Access Compliance Report

Public Rights-of-Way

Intersection ID: 43646	Main Street: CEDAR_CROSSINGS_DR	Cross Street: CALLOW_FOREST_DR	Location: SW
ADA ID: 2A2752AE83C7	Ramp Type: PerpDiag	Initial Pass/Fail: Fail	Overall Compliance: No
Severity Score: 10			
Codes/Mitigation Info/Possible Solution		Field Measurements/Component Compliance

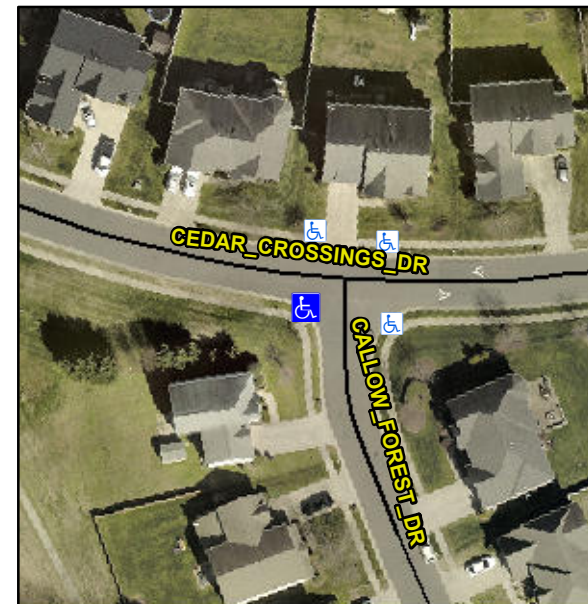
Not Found, R304.5.1, R304.5.3

Compliance	Description	Data	Compliance	Description	Data
N/A	Ramp Length (in)	48.0	Yes	Ramp Slope (%)	7.0
No	Ramp Width (in)	40.0	No	Ramp XSlope (%)	2.7
N/A	Flare Type LT	N/A	N/A	Flare Type RT	N/A
N/A	Flare Slope LT (%)	N/A	N/A	Flare Slope RT (%)	N/A
N/A	Flare Traversable LT?	N/A	N/A	Flare Traversable RT?	N/A
N/A	Landing Length (in)	N/A	N/A	DWS Provided?	N/A
N/A	Landing Width (in)	N/A	N/A	DWS Contrast?	N/A
N/A	Landing Slope (%)	N/A	N/A	DWS Length (in)	N/A
N/A	Landing X Slope (%)	N/A	N/A	DWS Full Width?	N/A
N/A	Landing Curb? (Y/N)	N/A	N/A	DWS Offset (in)	N/A
N/A	Shared Landing?	N/A			
N/A	Gutter Ponding?	N/A	N/A	Gutter Slope (%)	N/A
N/A	Gutter Lip Ht (in)	N/A	N/A	Gutter X Slope (%)	N/A
N/A	Painted X Walk1?	No	N/A	Painted X Walk2?	No
	X Walk 1 Direction	To E		X Walk 2 Direction	To N
N/A	X Walk 1 Width (in)	N/A	N/A	X Walk 2 Width (in)	N/A
	X Walk 1 Slope (%)	0.6		X Walk 2 Slope (%)	1.6
	X Walk 1 X Slope (%)	0.8		X Walk 2 X Slope (%)	0.5

Remove & Replace Curb Ramp With Two New Directional Ramps or Equivalent.
